Access Compliance Report

Public Rights-of-Way

(Curb Ramps)

Intersection ID: 54454	Main Street: COLLINGHAM_DR	Cross Street: STEELE_CREEK_RD	Location: SW
ADA ID: 3464E2D4E502	Ramp Type: Perp	Initial Pass/Fail: Fail	Overall Compliance: No
		Severity Score: 12.5

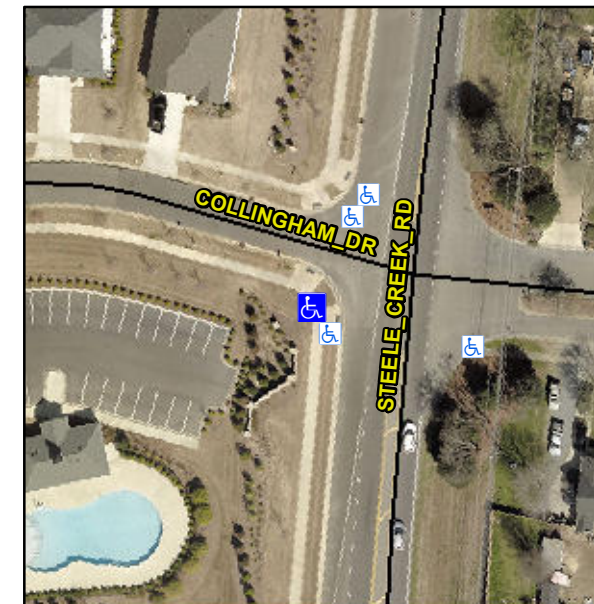
R304.2.2

Compliance	Description	Data	Compliance	Description	Data
N/A	Ramp Length (in)	103.0	No	Ramp Slope (%)	8.6
Yes	Ramp Width (in)	54.0	Yes	Ramp XSlope (%)	0.2
N/A	Flare Type LT	N/A	N/A	Flare Type RT	N/A
N/A	Flare Slope LT (%)	N/A	N/A	Flare Slope RT (%)	N/A
N/A	Flare Traversable LT?	N/A	N/A	Flare Traversable RT?	N/A
N/A	Landing Length (in)	N/A	N/A	DWS Provided?	N/A
N/A	Landing Width (in)	N/A	N/A	DWS Contrast?	N/A
N/A	Landing Slope (%)	N/A	N/A	DWS Length (in)	N/A
N/A	Landing X Slope (%)	N/A	N/A	DWS Full Width?	N/A
N/A	Landing Curb? (Y/N)	N/A	N/A	DWS Offset (in)	N/A
N/A	Shared Landing?	N/A			
N/A	Gutter Ponding?	Yes	N/A	Gutter Slope (%)	N/A
N/A	Gutter Lip Ht (in)	0.5	N/A	Gutter X Slope (%)	N/A
N/A	Painted X Walk1?	No	N/A	Painted X Walk2?	N/A
	X Walk 1 Direction	To NE		X Walk 2 Direction	N/A
N/A	X Walk 1 Width (in)	N/A	N/A	X Walk 2 Width (in)	N/A
	X Walk 1 Slope (%)	3.1		X Walk 2 Slope (%)	N/A
	X Walk 1 X Slope (%)	2.0		X Walk 2 X Slope (%)	N/A

Remove & Replace Entire Ramp.
